POWERHOUSE PARRAMATTA

DESIGN INTEGRITY REPORT

This report outlines the design integrity process and review that has occurred to support a modification application for Powerhouse Parramatta SSD-10416 for amendment of the pavilion roof and fit out and use of St George's Terrace.

Figure 1.
Modified roof top design

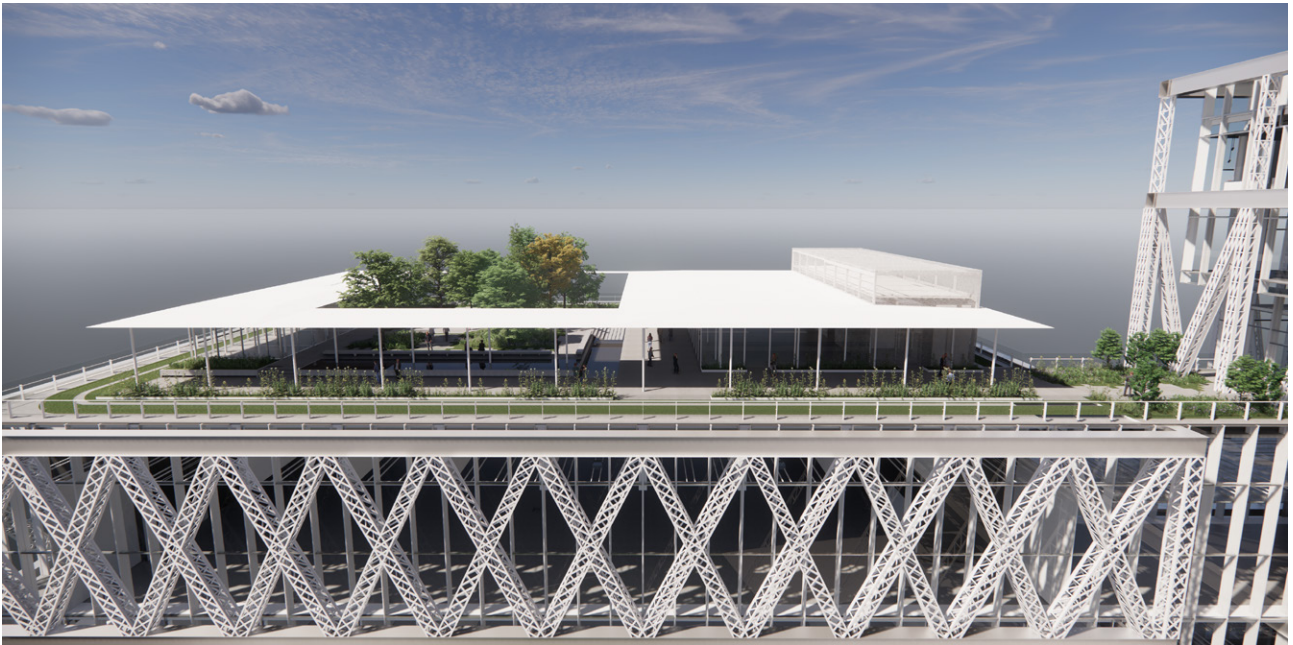
The Panel has reviewed the proposed design for the expanded pavilion and notes that:

- The structure remains well below the permissible height limit;
- The increase of the pavilion will enable it to service a wider array of functions;
- The expanded roof structure is light-weight and minimal in design and in-keeping with the remainder of the building; and
- The proposal represents a considered development of the design.
